NIAGARA FALLS BRIDGE COMMISSION

AS-BUILTS

RAINBOW BRIDGE DECK REPAIR AND MISCELLANEOUS REPAIRS AT THE WHIRLPOOL RAPIDS AND LEWISTON-QUEENSTON BRIDGES - CANADIAN SIDE

NFBC Project #2016-02-2B

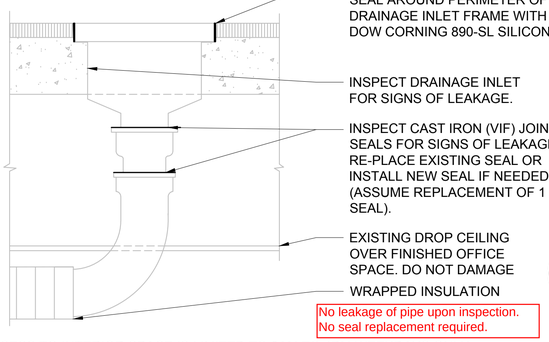
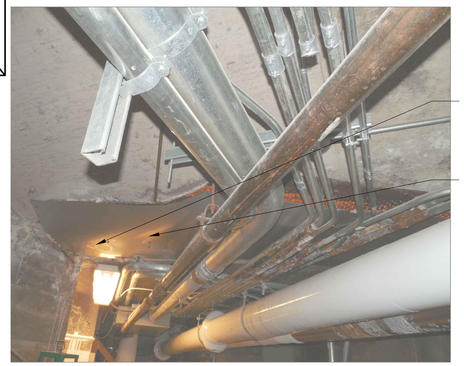
No leakage of pipe upon inspection. No seal replacement required.

DETAIL 1 - N.T.S.
EXISTING CONSTRUCTION JOINT

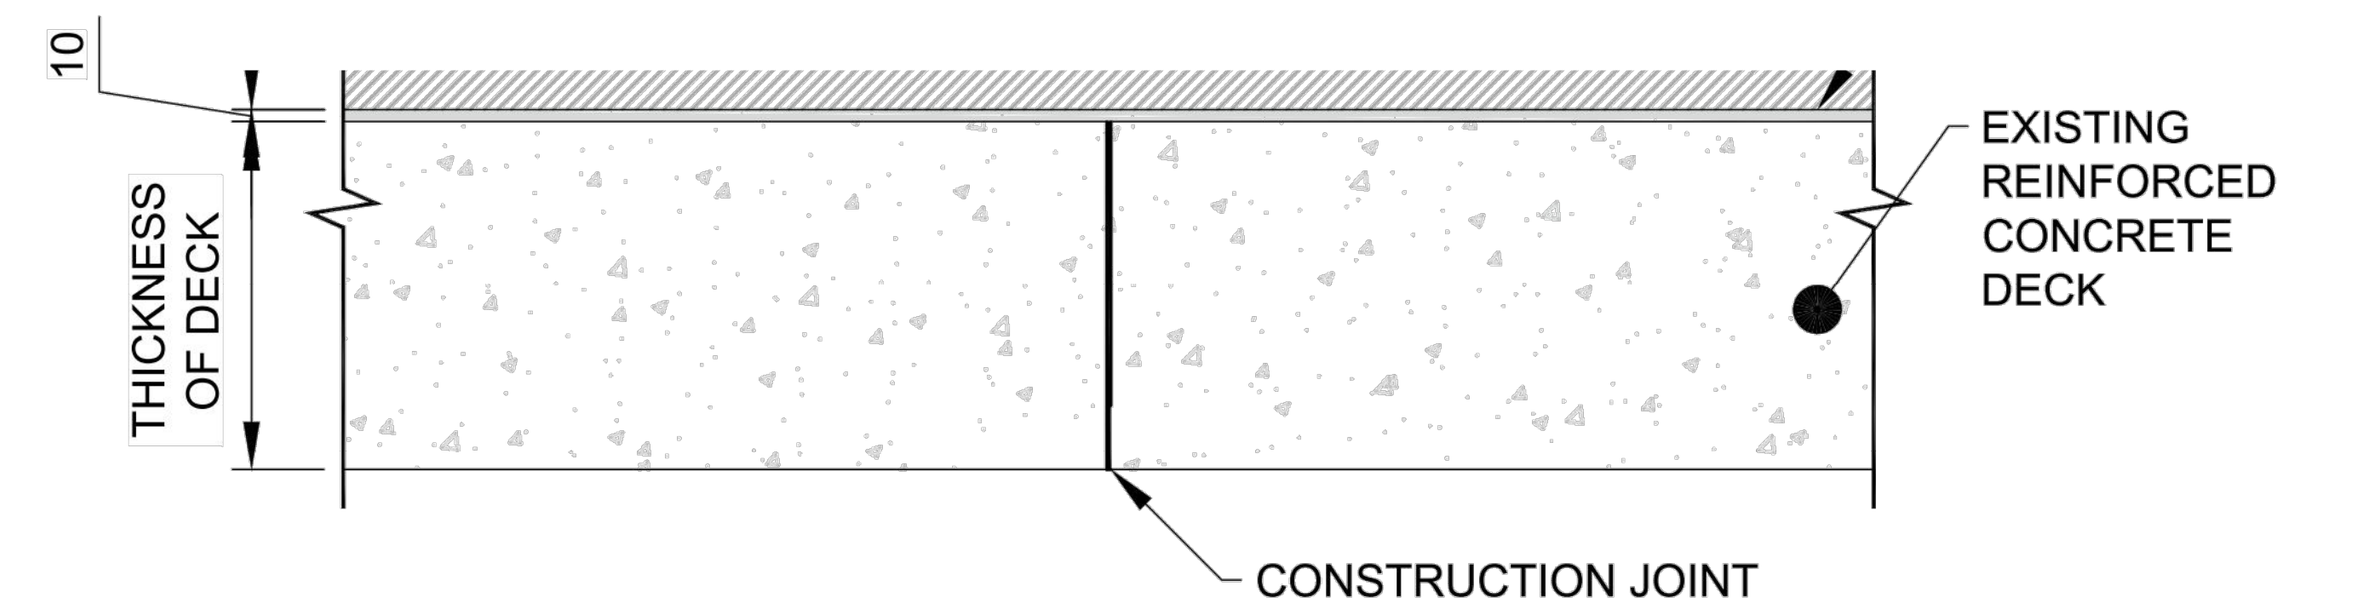
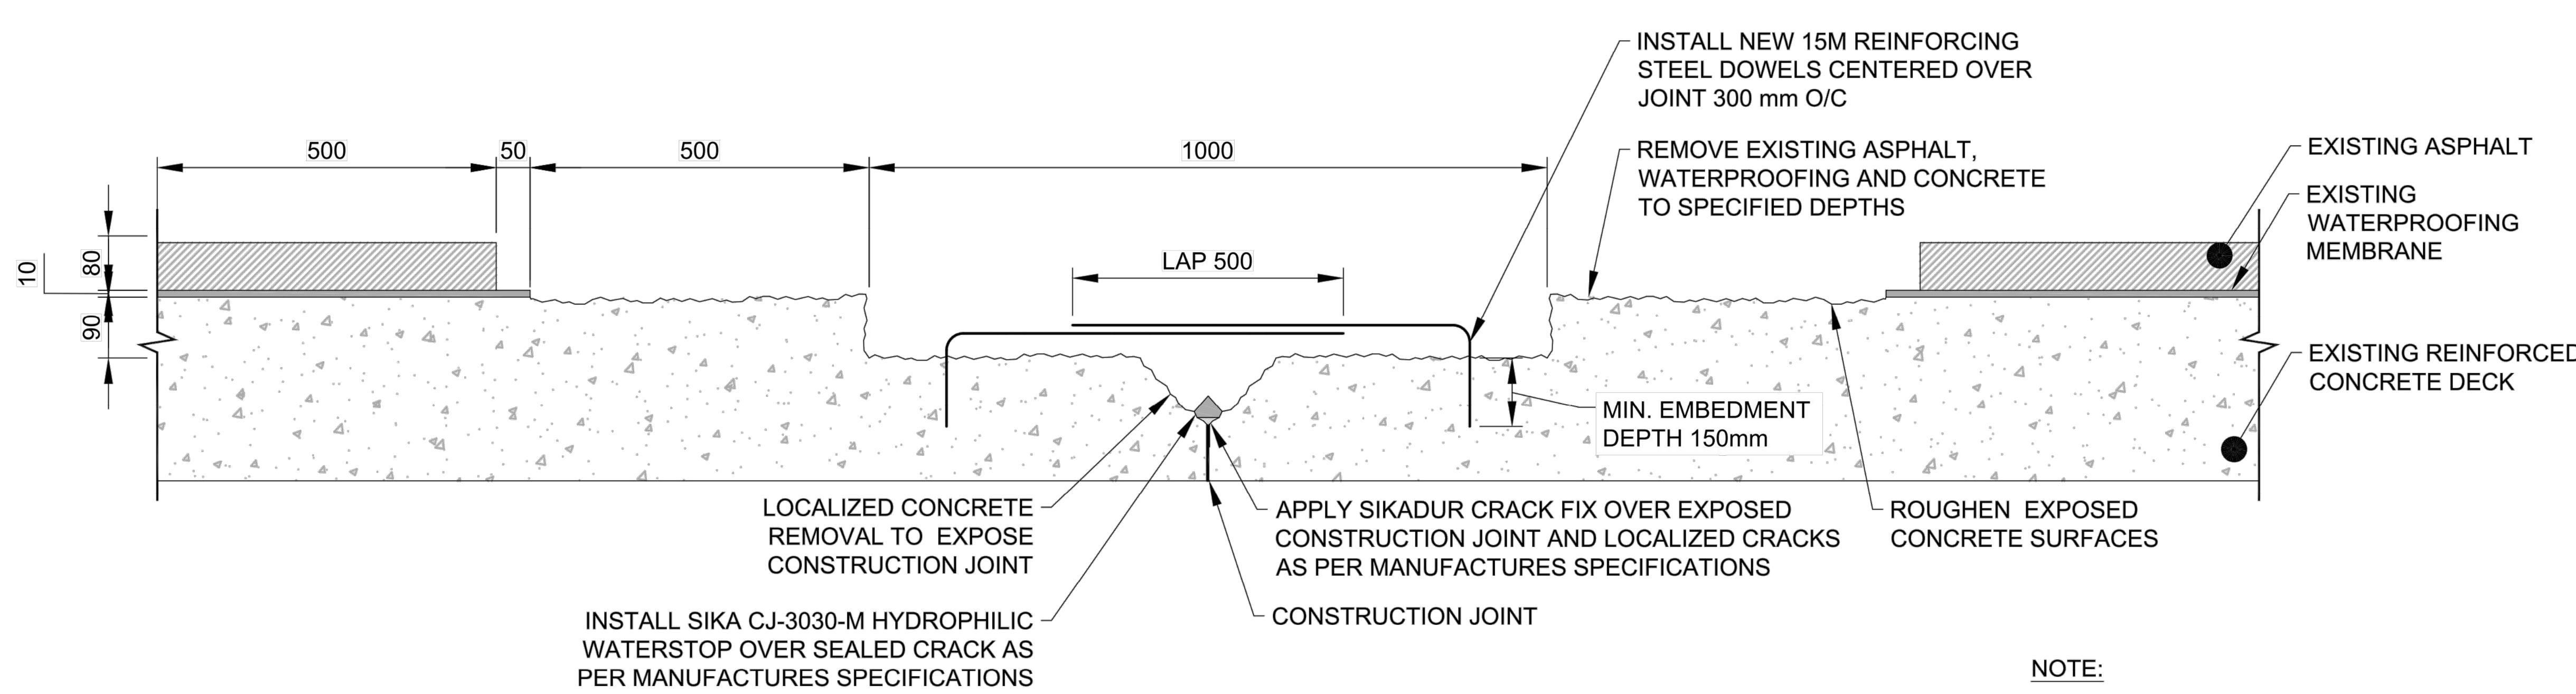
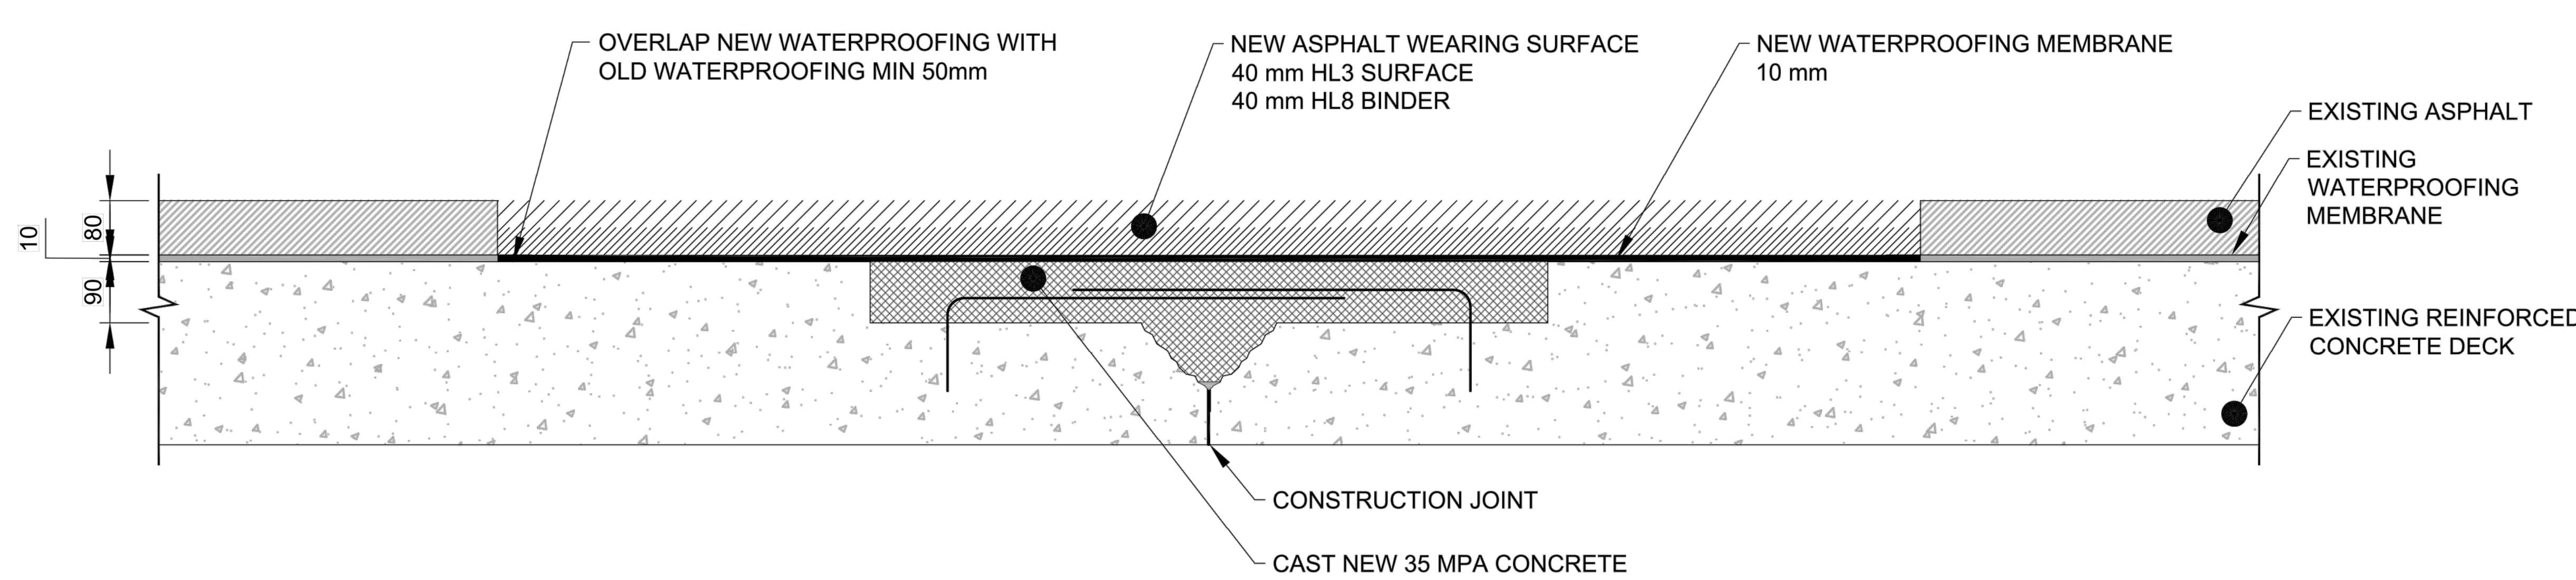
THIS REPAIR WAS NOT COMPLETED. ASPHALT REMOVED AND CONSTRUCTION JOINT COULD NOT BE FOUND.
